Product / Process Change Notification (PCN)

PCN Number: PCN_FeTOF_20250101

Affected Series: WE-TOF

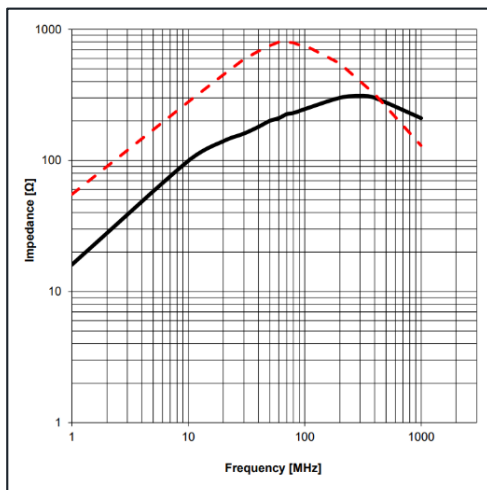
3. The visualization of chart for the “**Typical Impedance Characteristics**” changes. The used type of cable and cable length is shown in each chart.

Before change:

- Showing only one graph with 1 turn (1T) and 2 turns (2T) impedance curves.

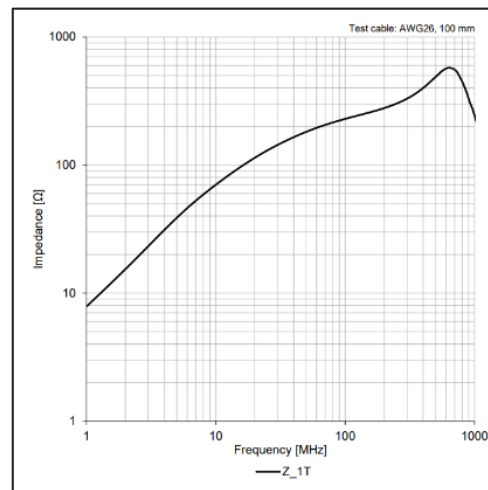
After change:

- Showing a graph for the 1 turn (Z_1T) impedance curve with the shortest possible cable length according to the product.

- Showing no graph with 3 turns impedance curve.

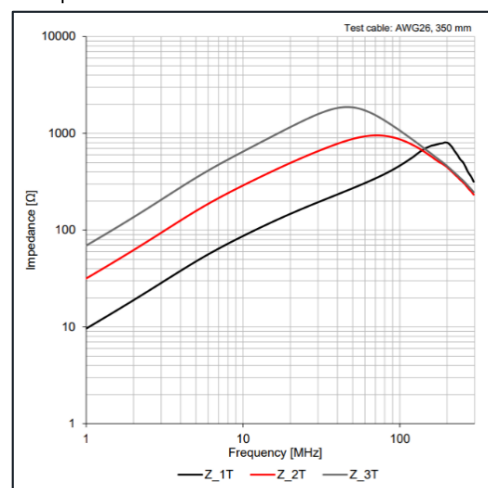
- Showing a graph for 1-3 turns (Z_1T, Z_2T, Z_3T) impedance curves with the shortest possible cable length, which is required for 3 turns according to the product.
